# UNITED STATES PATENT AND TRADEMARK OFFICE

APPLICATION NO.	FILING DATE	FIRST NAMED INVENTOR	ATTORNEY DOCKET NO.	CONFIRMATION NO.
09/868,938	07/18/2001	Kiyoshi Nishio		4331

**FINAL ACTION**

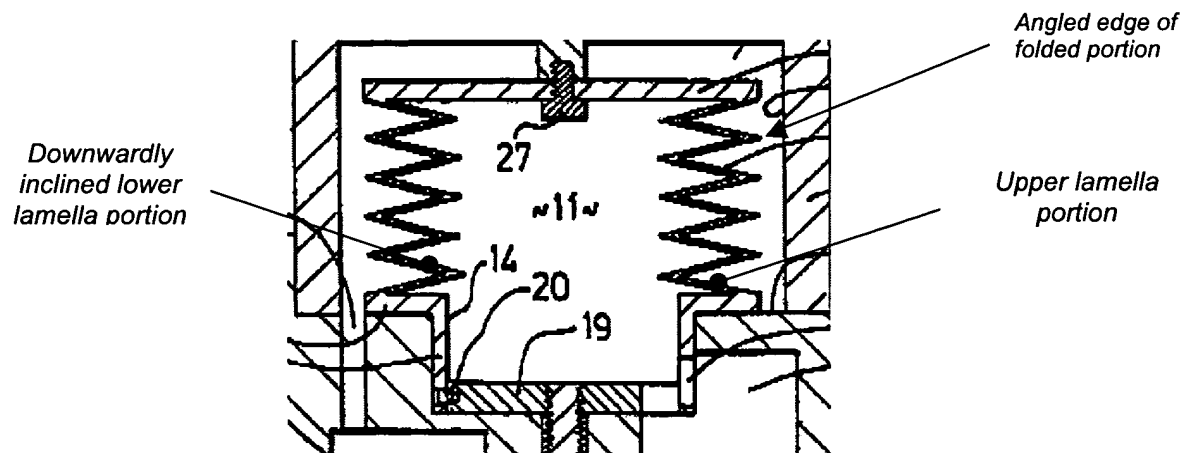
3. Claims 7 and 10 are rejected under 35 U.S.C. 103(a) as being unpatentable over Thomin et al. (WO 99/31388) in view of Boedecker et al. (4,655,690). Thomin et al. teach a fluid apparatus having a bellows 12 with extending and contracting portions configured by forming ridge-like folds and valley-like folds 18 in a vertically alternate and continuous manner, that are extendingly and contractingly deformable in an axial direction. The bellows are placed in a pump body 1 such that the axial direction defines a vertical axis. Figure 2 illustrates an inner pumping chamber 11 (corresponding to the claimed liquid chamber) formed inside of bellows 12; an outer pumping chamber 10 (corresponding to the claimed air chamber) formed outside of the bellows 12; and a

suction (or inflow, as in claim 4) port 43 and a discharge (or outflow, as in claim 4) port 45 formed in an inner bottom face of the pump body facing the inner pumping chamber. Figure 2 further illustrates that the bellows are formed into a shape in which a lower one of upper and lower lamella portions of each of the ridge-like folds is downwardly inclined toward the vertical axis, in both the extending and contracting state (see the accompanying figure), and the edges of the folded portion are angled.

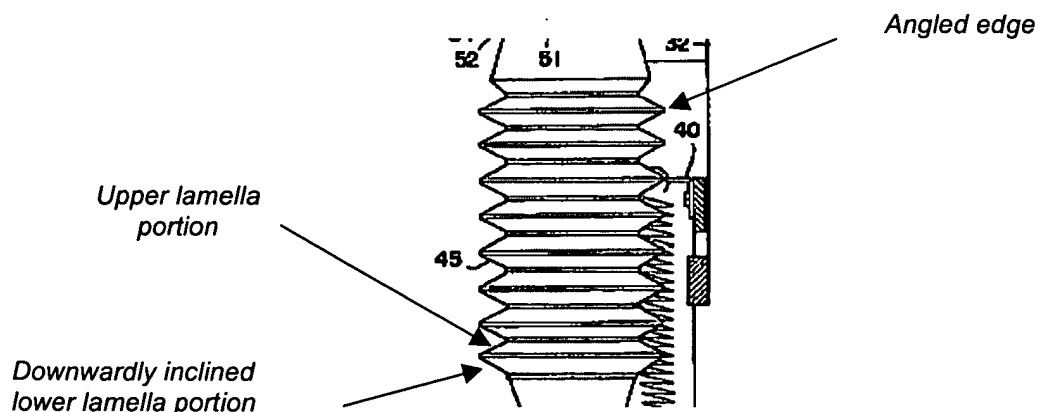
4. Claims 7 and 10 are rejected under 35 U.S.C. 103(a) as being unpatentable over Hope et al. (4,231,724) in view of Boedecker et al. Hope et al. teach a fluid apparatus having a bellows 45 configured by a pump in which a bellows that has an extending and contracting portion configured by forming ridge-like folds and valley-like folds in a vertically alternate and continuous manner (see column 5, lines 7-13), and that is extendingly and contractingly deformable in an axial direction. The bellows 45 are placed in a main frame 12 (corresponding to the claimed pump body) such that the axial direction extends along a vertical axis, and include a chamber inside of the bellows. Hope et al. further teach a suction port 83 and a discharge port 63 and that the extending and contracting portion of the bellows is formed into a shape in which a lower one of upper and lower lamella portions of each of the ridge-like folds is downward inclined toward the vertical axis, in both the extending and contracting state (see the accompanying figure), and the edges of the folded portion are angled. With regards to

claim 10, since the bellows are exposed to air, it stands to reason that there is an air chamber outside of the bellows. That is, outside of the bellows 4 and within main frame 12, constitutes the claimed air chamber.
